|  | <h1 style="text-align: center;">CONCESSION</h1> | | | | Reference | TN-006535195 |
| | Part Description | CLIP INSTL RH S13/14 | | | A/C Type | A350-1000 |
| Description of Divergence Location:FUSELAGE SECTION 13/14,ON LOWER PART,STRUCTURE,RIGHT SIDE,EXTERNAL SURFACE AFFECTED Frame 036,From Stringer 36 to 38 NonConformity 0001 : Type of nonconformity: Oversized Hole Characteristics Nominal hole specification : ABS1707BC8V3A Nominal Fastener Sys-fastener : ABS0873B3E + ABS1826K3 Drilled Hole Specification : ABS1707BC8V3AX Nominal Pitch & Edge Distance : Yes (see Sketches) NON CONFORMITY: OVERSIZE FASTENERS INSTALLED SEE MORE DETAILS IN SKETCHES AFFECTED PARTS: | | | | Responsible Design Office Decision Acceptable as is ASR limits not exceeded NONCONFORMITY: OVERSIZE FASTENERS INSTALLED -Acceptable as is | | Attached documents 2 pages |

UP
FWD VIEW LOOKING OUTBOARD

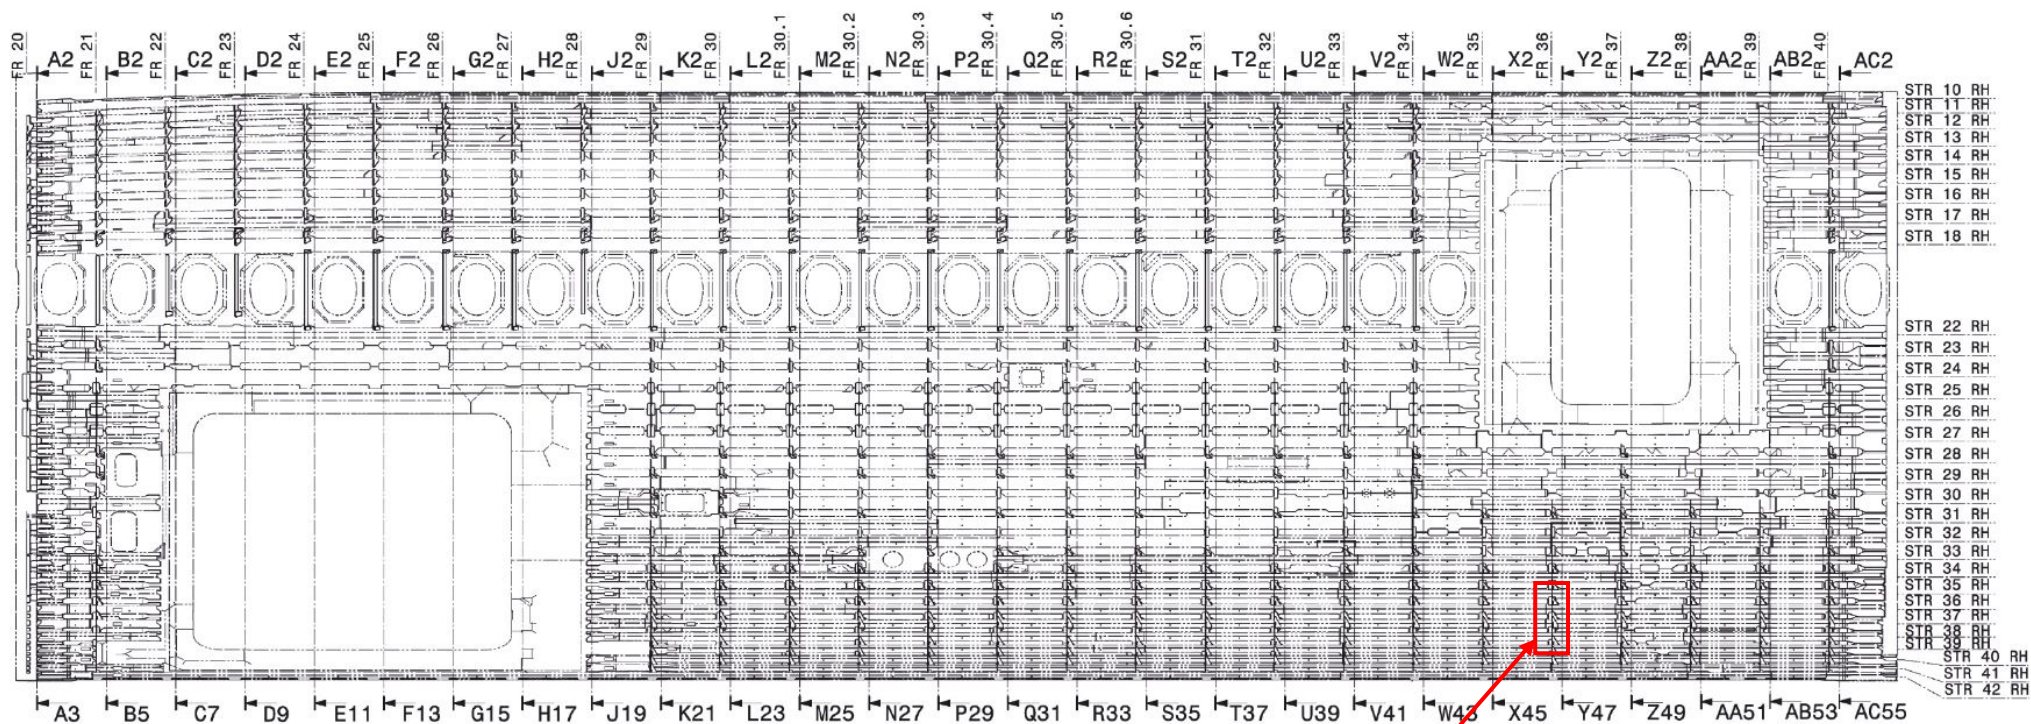
AFFECTED AREA - FRAME 36, STRINGER 36 RH - 38 RH
NON CONFORMITY: OVERSIZE FASTENERS INSTALLED
SEE MORE DETAILS IN SKETCHES

SURFACE PROTECTION WILL BE COMPLETED DURING
MANUFACTURING ACCORDING TO DESIGN SOLUTION

VIEW B47-48

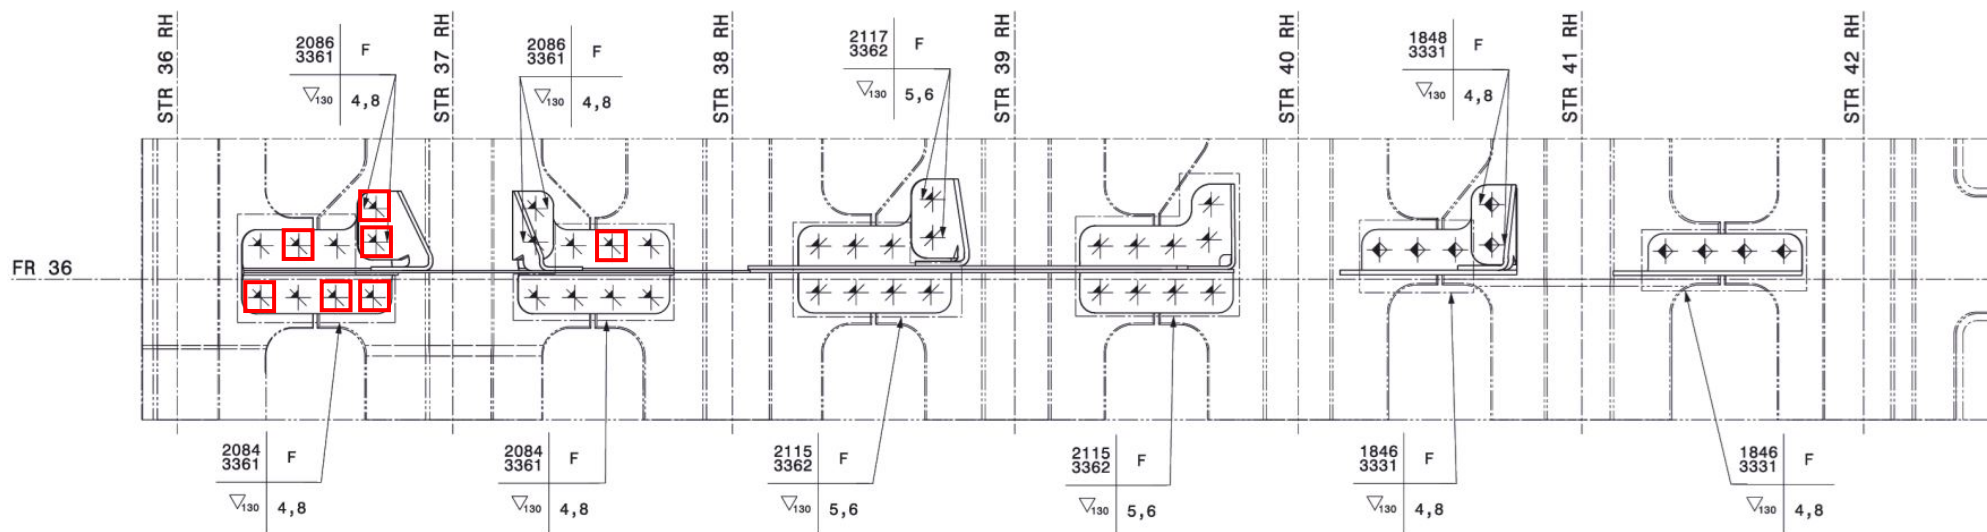
NON CONFORMITY: 7x OVERSIZE FASTENERS INSTALLED.

NOMINAL:

HOLE CODE: ABS1707BC8V3A

FASTENERS: ABS0873B3E + ABS1826K3

ACTUAL:

HOLE CODE: ABS1707BC8V3AX

FASTENERS: ABS0873B3XE + ABS1826K3

HOLES POSITION, EDGE AND PITCH DISTANCE AS PER DRAWING.
